2-WIRE NO. 1A ELECTRONIC SWITCHING SYSTEM

GENERAL DESCRIPTION

1.001 This addendum supplements Section 966-120-100, Issue 2. Place this pink sheet ahead of Page 1 of this section.

Fig. 18—Remreed Line Link Network Frame Configurations

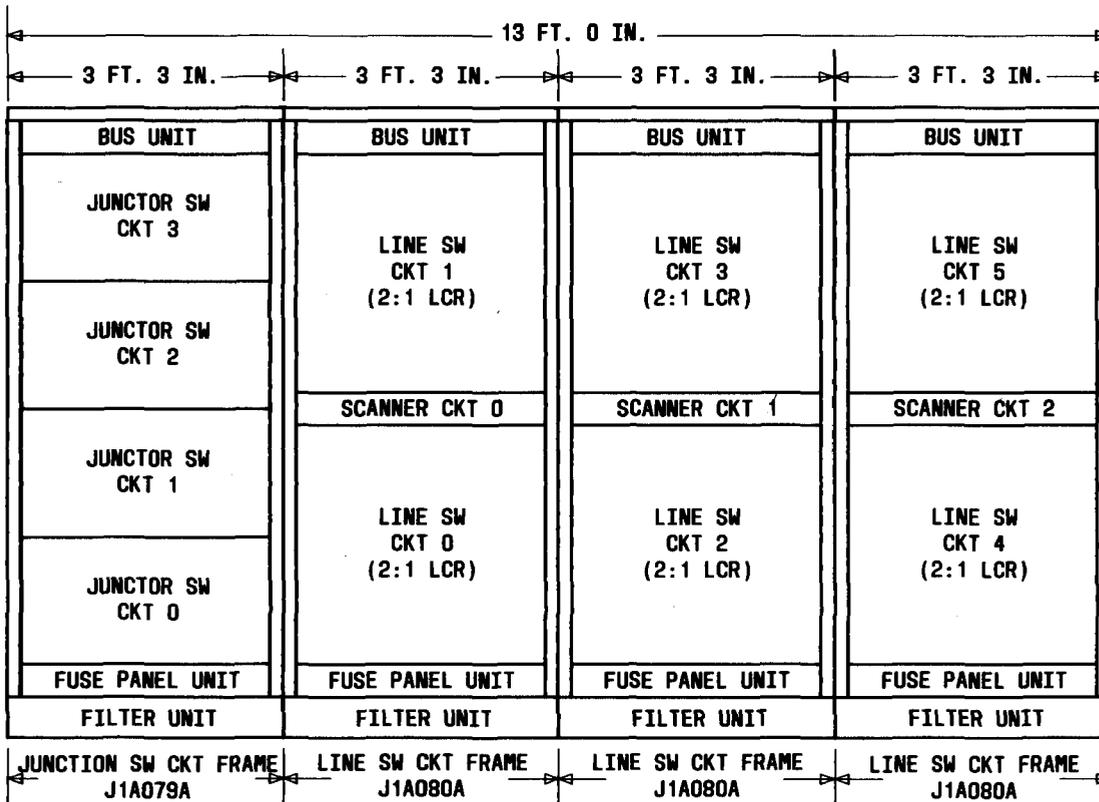
2.001 On page 31, in Fig. 18, the junctor switching circuit frame should be shown on the left of the configuration in both illustrations. The attached Fig. 18 shows the correct configuration.
